**NOTICE OF A REGULAR MEETING
BONDURANT PLANNING AND ZONING COMMISSION
SEPTEMBER 12, 2019**

ITEM TITLE: Resolution regarding the Site Plan for Roadside Machinery & Supplies Co.

To: Marketa Oliver, City Administrator
From: Brad Scheib, AICP, and Beth Richmond, Hoisington Koegler Group Inc.
Re: Planning Report/Review of Site Plan – RMS Bondurant
Date: 05 September 2019
Applicant: Jensen Builders Ltd (Jason Crimmins)
Location: Outlot X McCleary Meadows Industrial Park
Comprehensive Plan: Industrial
Zoning: M-1 Limited Industrial

BONDURANT, IOWA
RMS BONDURANT
SITE PLAN REVIEW COMMENTS

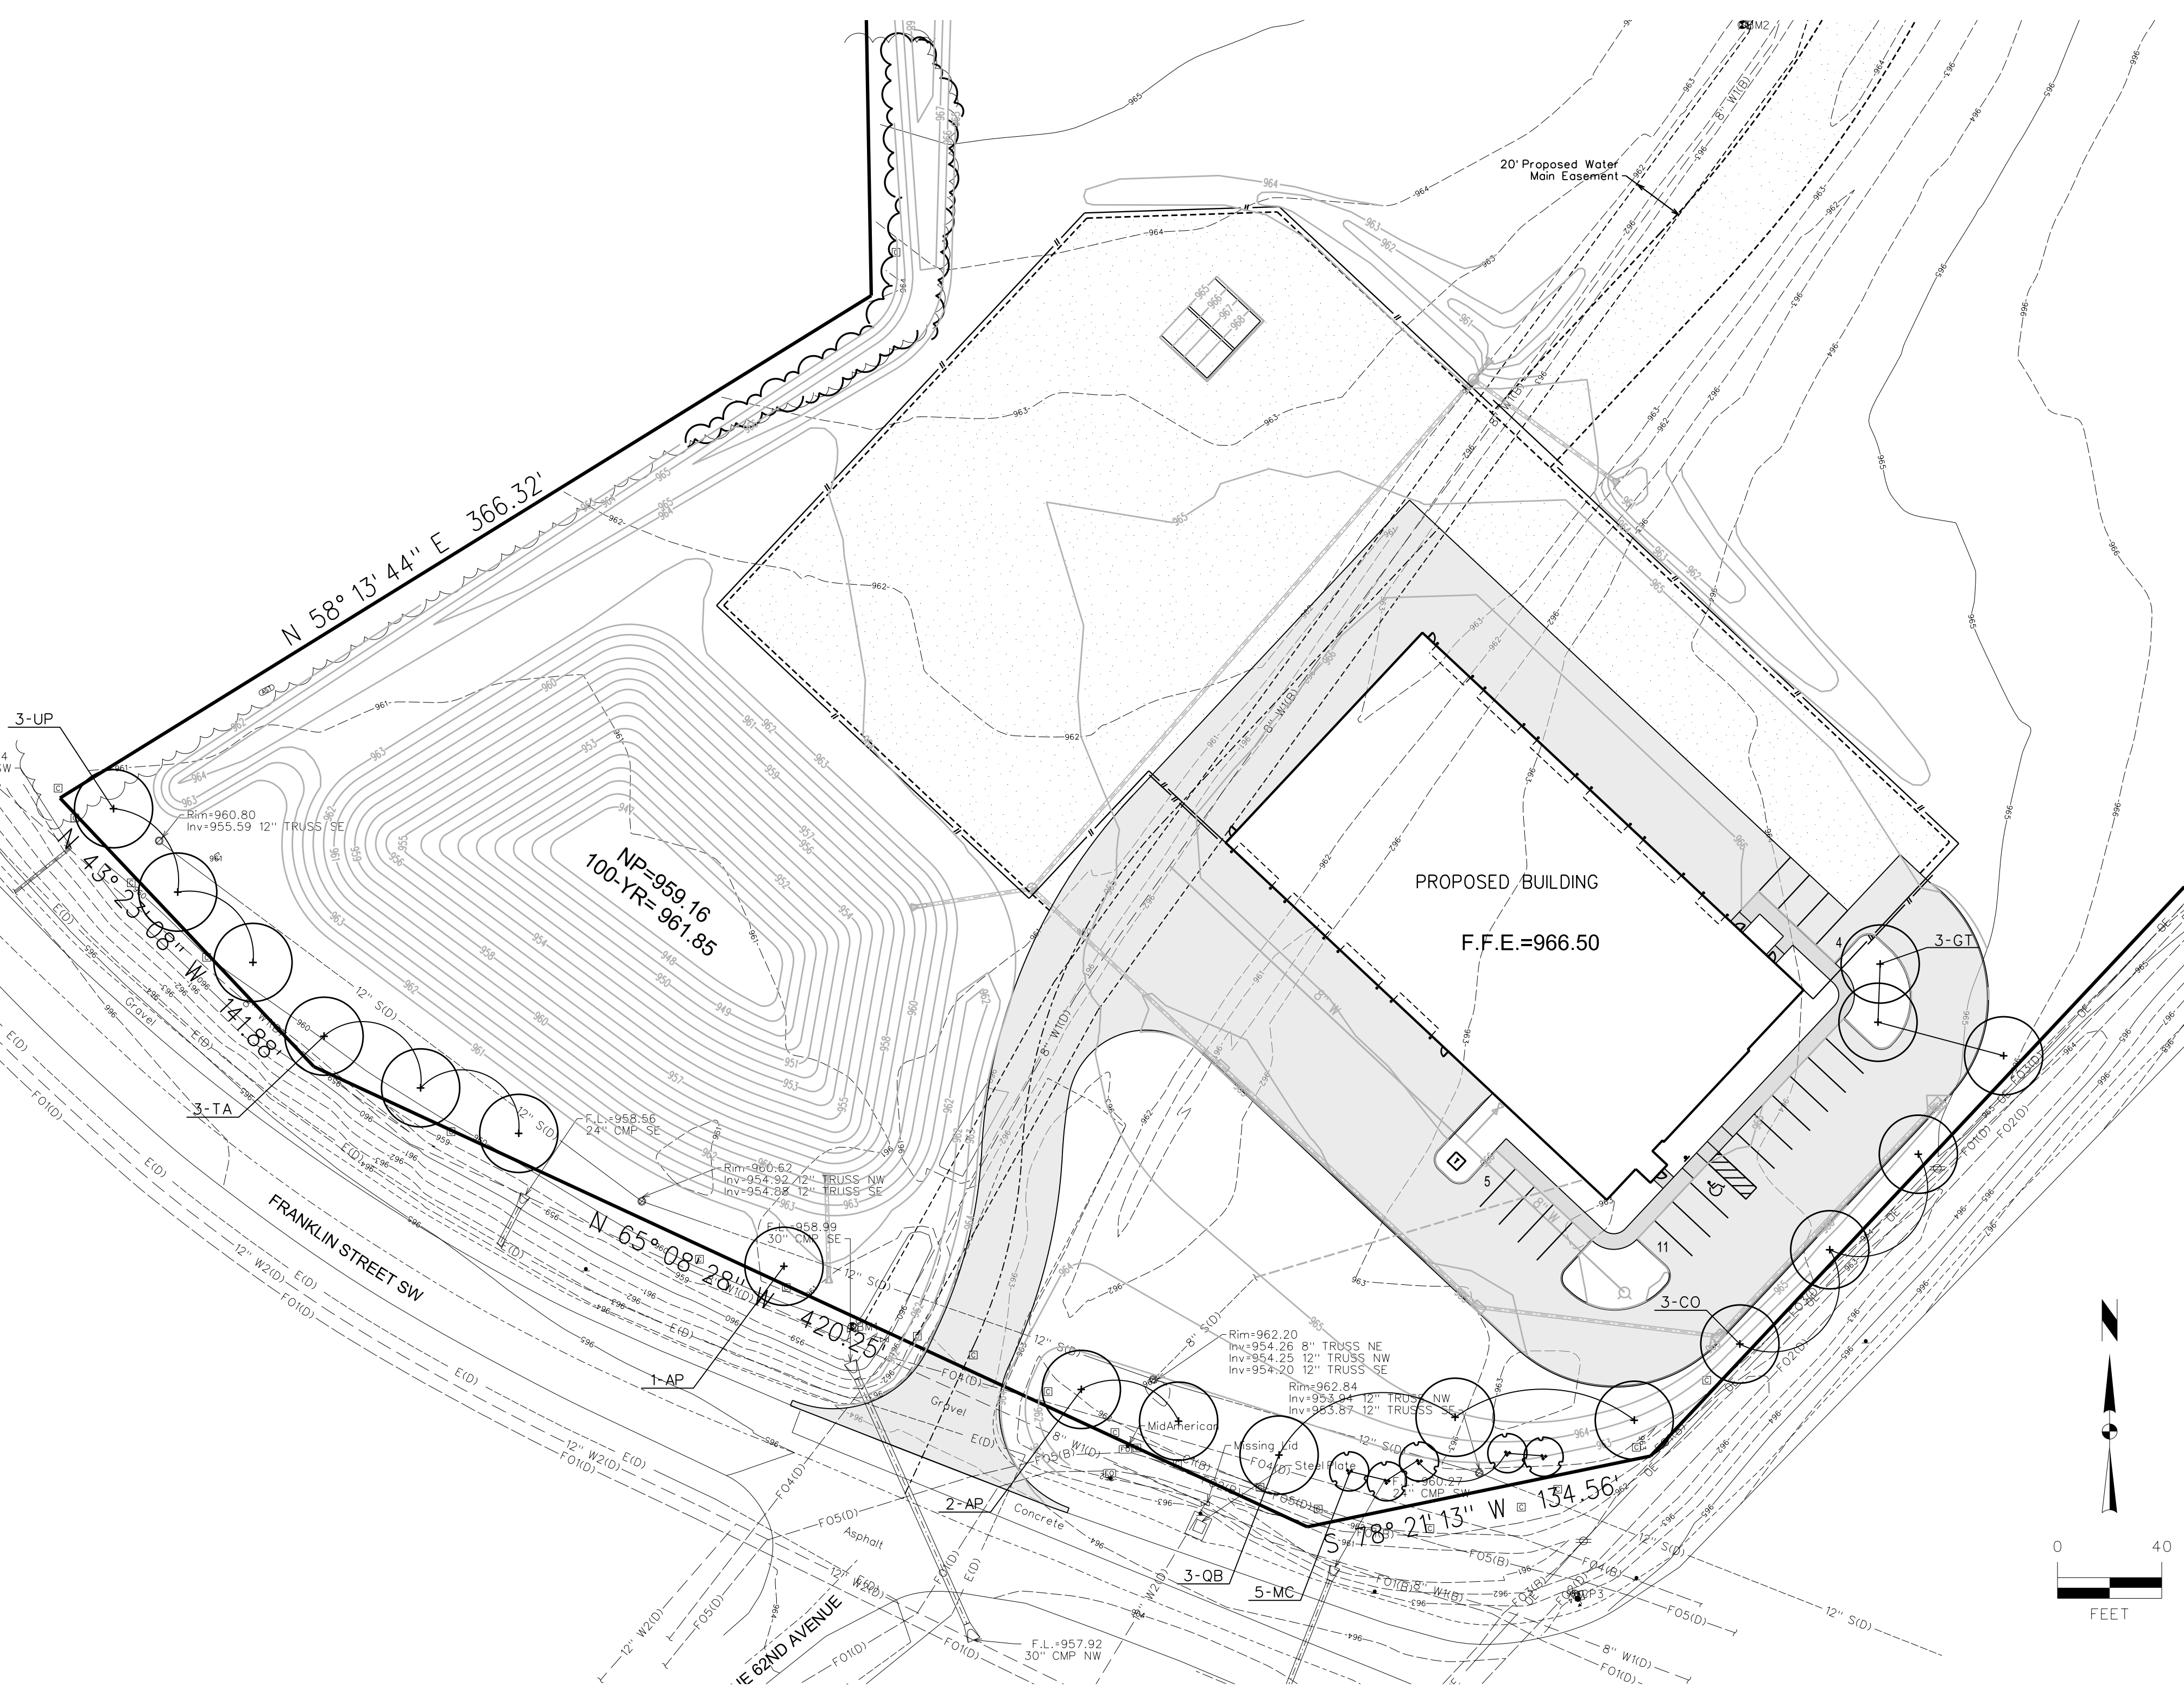
The proposed building is 22,264 square feet. Therefore, 2 off-street loading spaces are required. The site plan proposes two loading spaces near the northwest corner of the building. These loading spaces must be no less than 10 feet by 25 feet and must be screened from view in accordance with Code 177.10.

The drive serving the parking spaces must be 16 feet in width. The drive is proposed to be 30 feet wide which is larger than necessary. This drive could be narrowed, providing additional open space around the site. There are four proposed parking spaces in the rear of the building. The proposed drive only serves one of these parking spaces. Staff recommends continuing the paved drive to provide access to each of the parking spaces in the rear of the building as a condition of approval.

A chain link fence is proposed to be located around the west and north sides of the building between the site and the residential properties. However, a chain link fence is not considered opaque and therefore additional screening will be required meeting the standards for fences in Code sections 177.02 and 179.02.4C. Barbed wire is proposed to be placed on the top of the chain link fence. Barbed wire prohibited by Code to be used as a fence material, and will therefore not be allowed as part of this site plan.

Dumpster areas are not shown on the site plan. As a condition of approval, all dumpster areas shall be enclosed within the building itself or screened from view using dense vegetation or a fence.

LANDSCAPE PLAN

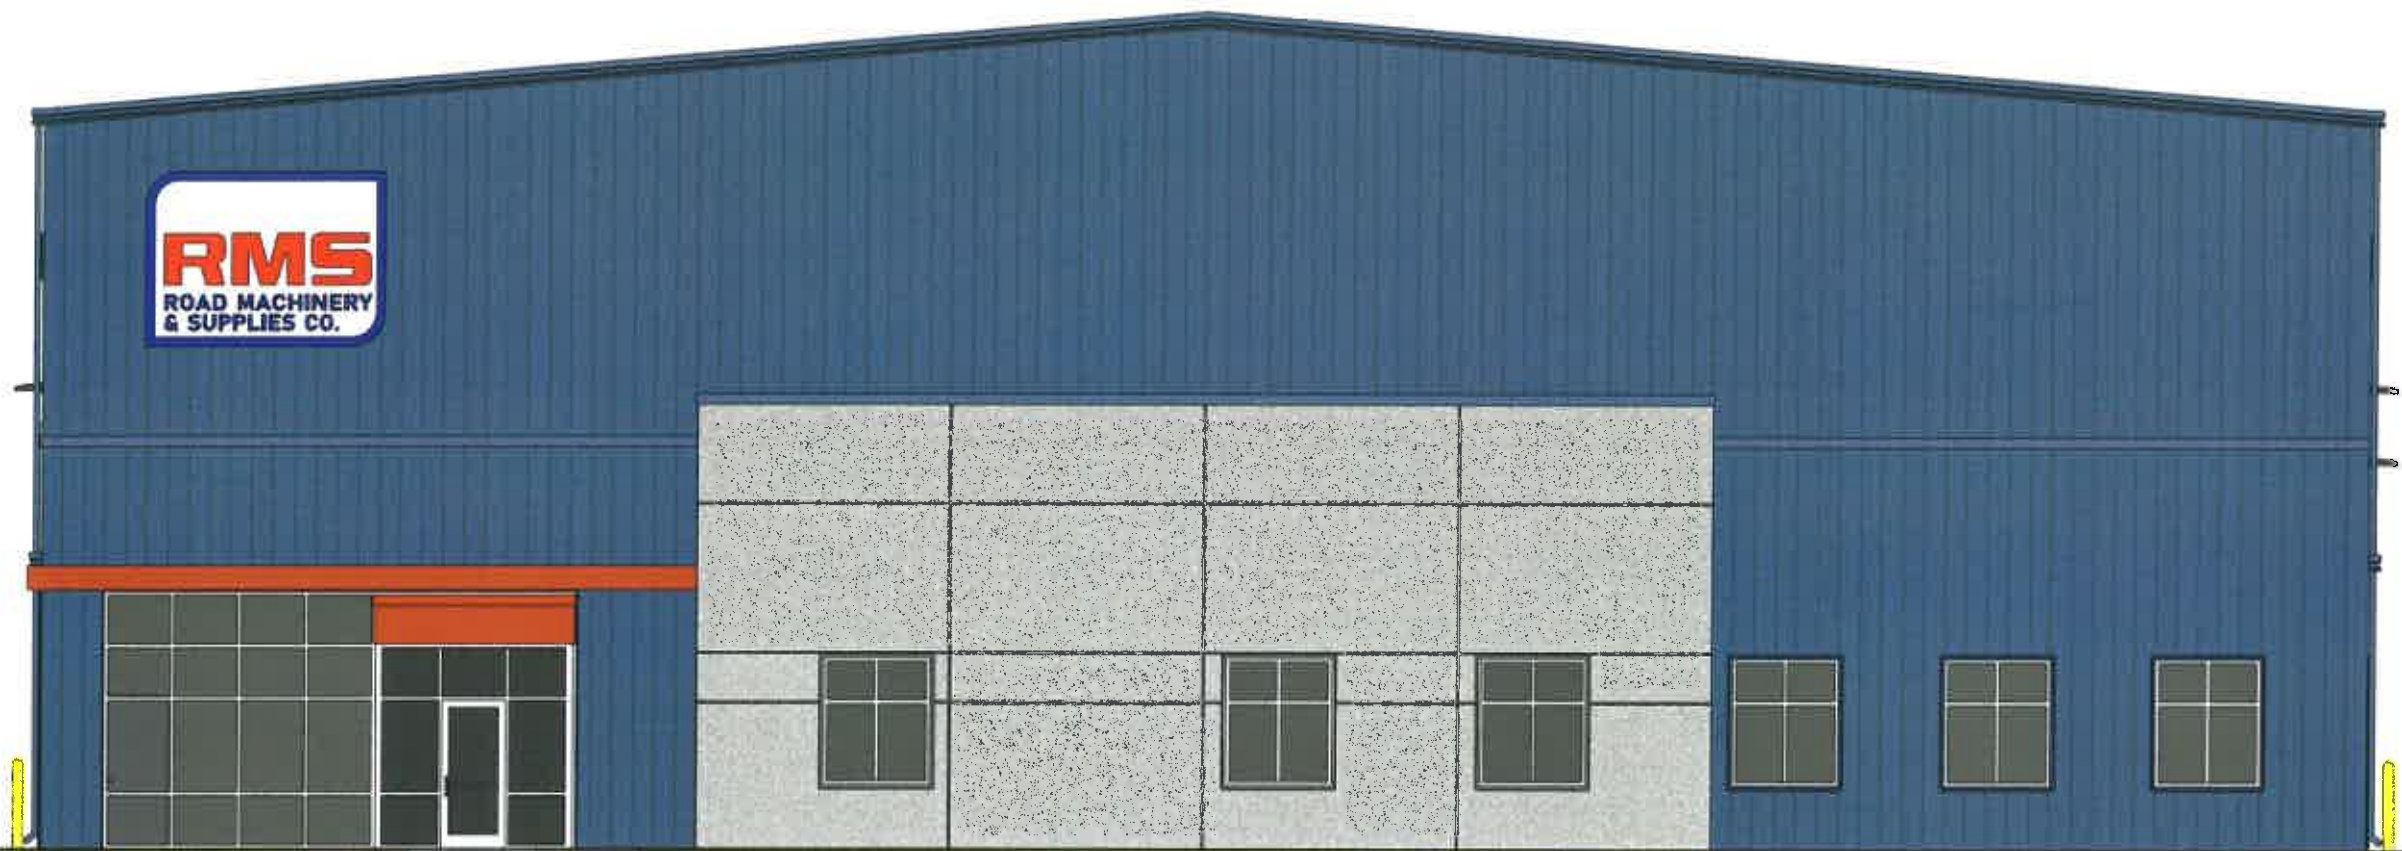
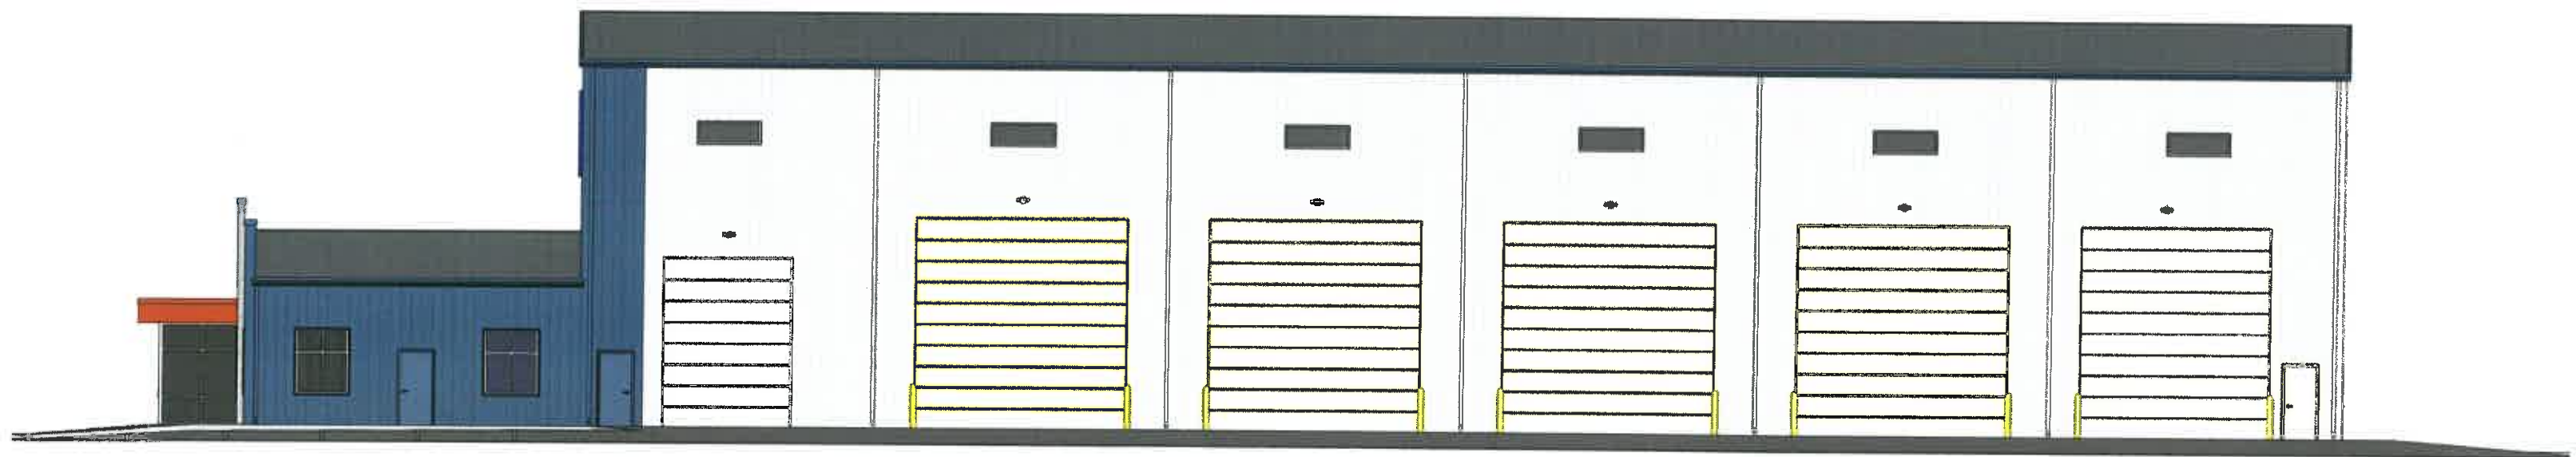
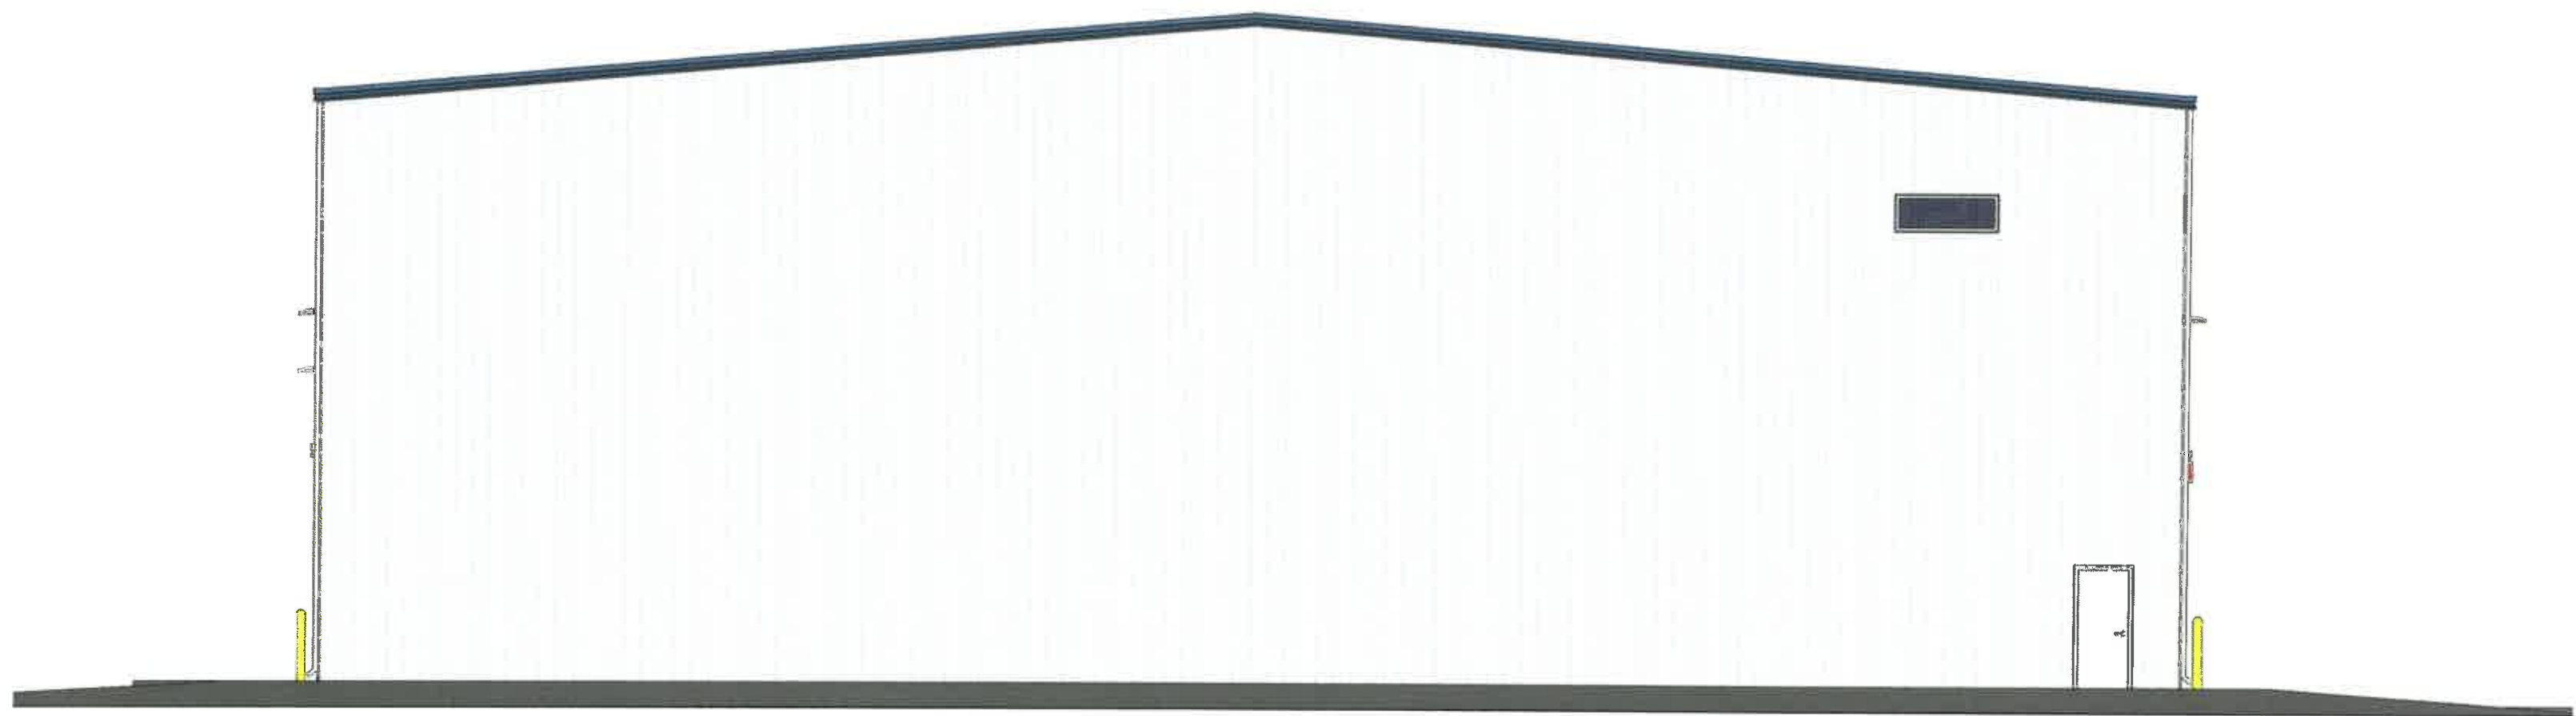
Deciduous trees must be planted with a minimum caliper of 1 ¾ inches. The landscaping plan proposes deciduous trees with a 1 ¼ inch caliper. The plans must be revised to show 1 ¾ inch caliper for all proposed deciduous trees as a condition of approval.

90% of the required open space area (or roughly 2.1 acres) must be landscaped and maintained with living ground cover. As a condition of approval, the applicant must specify the landscaped areas on the site plan, the type of landscaping/surfacing, and their acreage to meet 90% of the required open space.

13. No more than 50 percent of all proposed trees may be “quick-growing.”
14. The plans must be revised to show 1 ¾ inch caliper for all proposed deciduous trees.

17. The applicant shall specify the type and acreage of each ground cover and/or landscaping that will make up the required open space and landscaping area on the landscaping plan.
